ACOUSTI-IMPACT PANELS (AIP)

Resubmittal of
098433-007

Project Name: Webster University Interdisciplinary Science Building Project No.: 15051

RE: Acoustical Wall Panel Product Data REV1

CORE SECTION

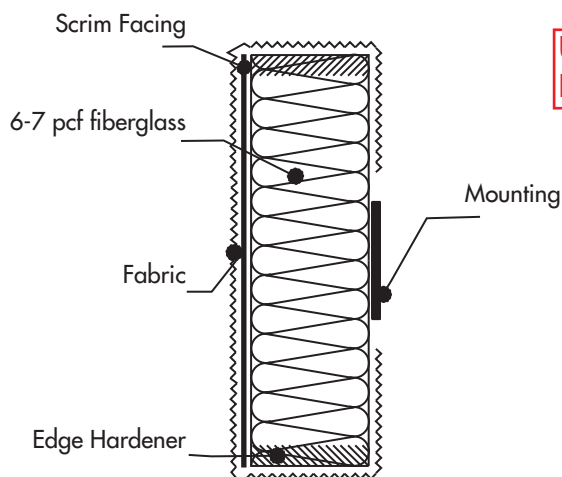
Used for AP-1 and
FAP-1 per RFI-038

N.R.C. value per re-
submittal requirements
